DOE-NRC Technical Exchange/Management Meeting Agenda
KEY TECHNICAL ISSUES AND SUBISSUES RELATED TO CRITICALITY
9960 Covington Cross (M&O Complex in Summerlin), Room 915, Las Vegas, Nevada
October 23 and 24, 2000

Objective: Provide the basis to resolve open Key Technical Issues (KTIs) related to Criticality.
Also, provide the basis to resolve criticality Safety Evaluation Report (SER) open items.

Criticality - Summary of Status from a DOE Perspective

Disposal Criticality Topical Report Update

Figure 3-5. Criticality Analysis Methodology

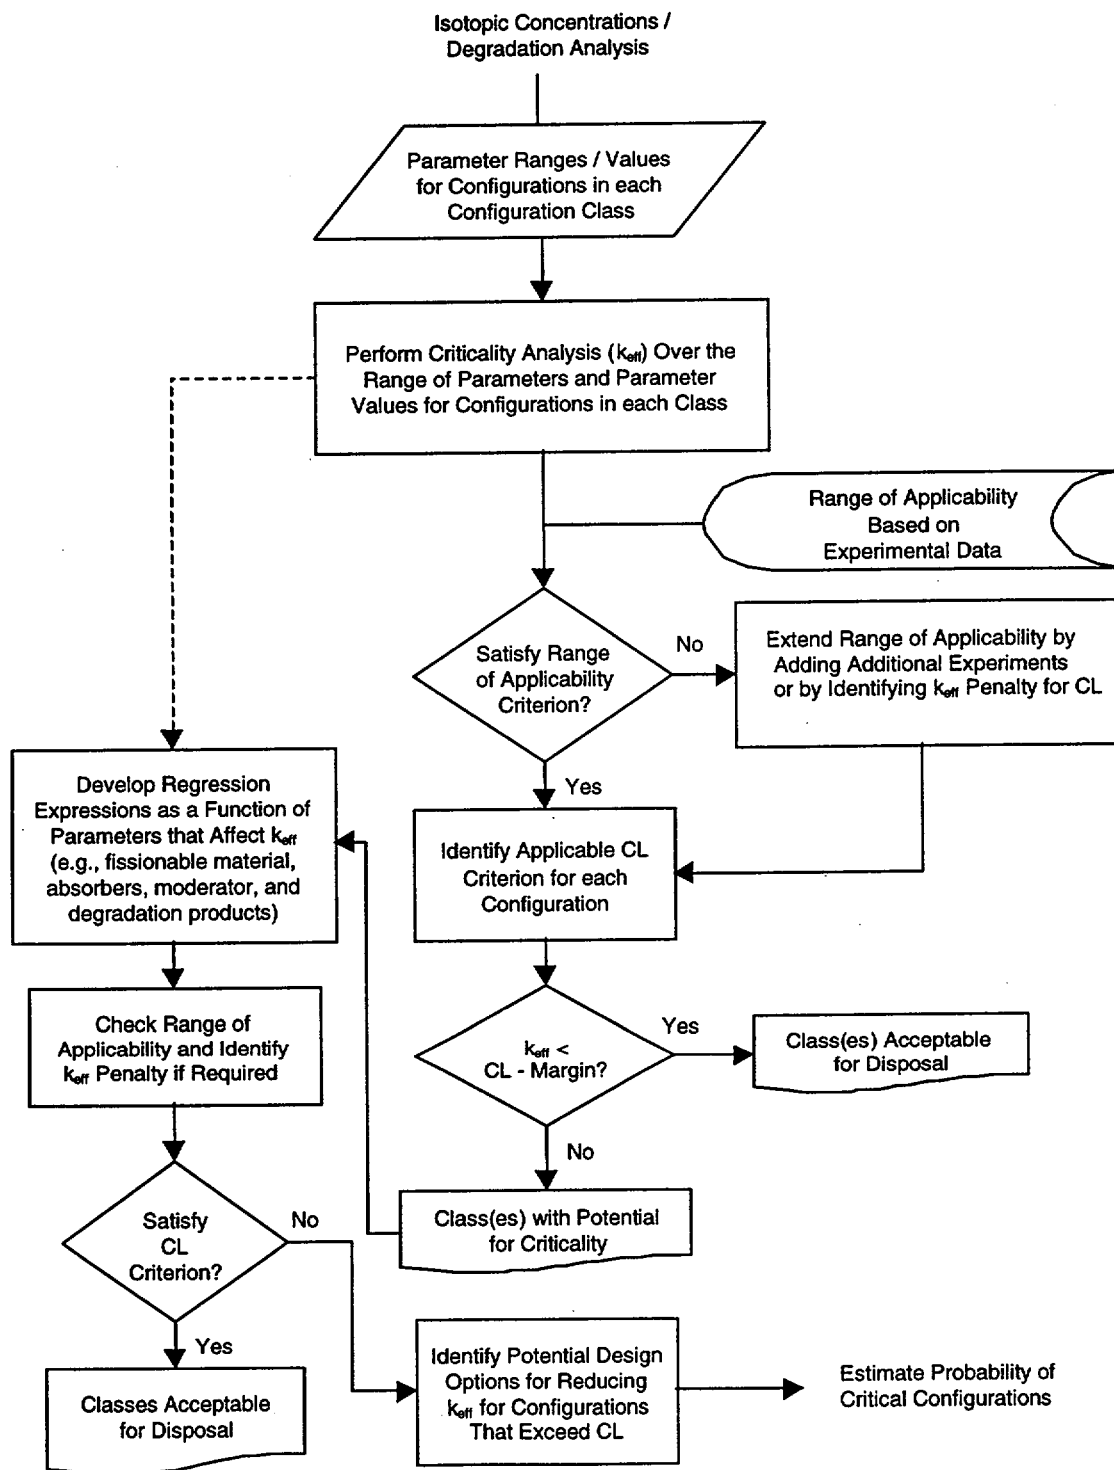
- **“The DOE should describe the interface between Figure 1-1 of the RAI [Request for Additional Information] responses and the TSPA [Total System Performance Assessment] criticality risk analysis.”**
 - Topical Report, Rev. 01, Section 3.8.1, page 3-91
 - Topical Report, Rev. 01, Section 3.8.2, page 3-93
 - Discussed in presentation
 - ♦ Container Life and Source Term Subissue 5, Acceptance Criterion 7: Risk

- **Action or information needs identified**
 - DOE should describe the interface between Figure 1-1 of the Request for Additional Information responses (now Figure 3-1 of the Topical Report, Rev. 01) and the Total System Performance Assessment criticality risk analysis Open Item 28.
 - Need for a “What-if” evaluation of the impact of a non-mechanistic criticality during the first 10,000 years after repository closure
